1<sup>st</sup> REVIEW COMMENT LETTER RESPONSES BY APPLICANT. RESPONSES ARE PROVIDED IN **BOLD TEXT BELOW**.

RE: **1-MP-2021**  
Fiesta Ranch  
**3380C (Key Code)**

The Planning & Development Services Division has completed the review of the above referenced development application submitted on August 3, 2021. The following **1<sup>st</sup> Review Comments** represent the review performed by our team and is intended to provide you with guidance for compliance with city codes, policies, and guidelines related to this application.

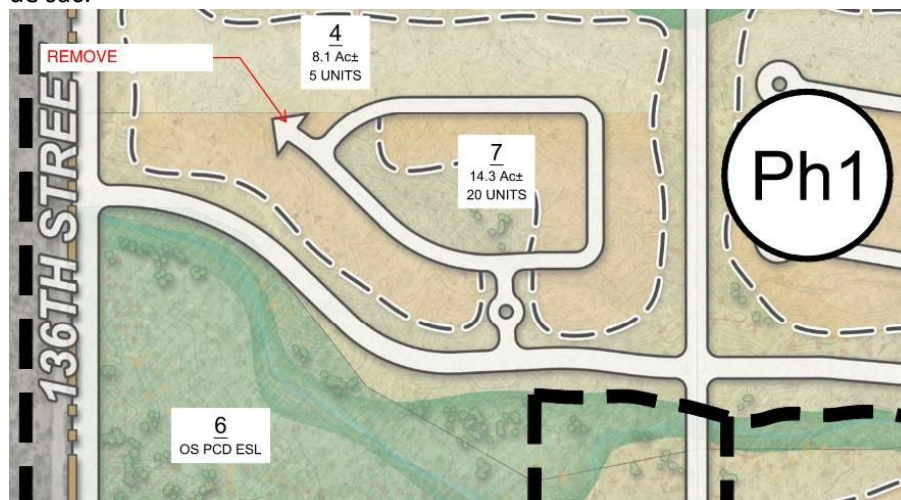
- d. Phase 4 boundary to remove 141<sup>st</sup>.

- e. Phase 1 boundaries modified to include improvements along lift station gravity and forcemain corridors such that any. not currently proposed within phase 1 boundaries impacted, local collectors shall be fully improved and residential roads improved to unpaved standards (coordinate with Wastewater master plan).

**RESPONSE:** Based on required infrastructure, the applicant does not agree with or understand this request. Phase 4 is the phase that would require the crossing and infrastructure, not Phase 2. Significant infrastructure is required with Phase 1 to support this project and deferring infrastructure until appropriately required is very important to the ability to develop the project. The project is owned by a single entity and is responsible for the entire project.

**RESPONSE: Noted. utilities and access route to LS will require improvements with Phase 1 to meet City standards prior to Parcel/lot development.**
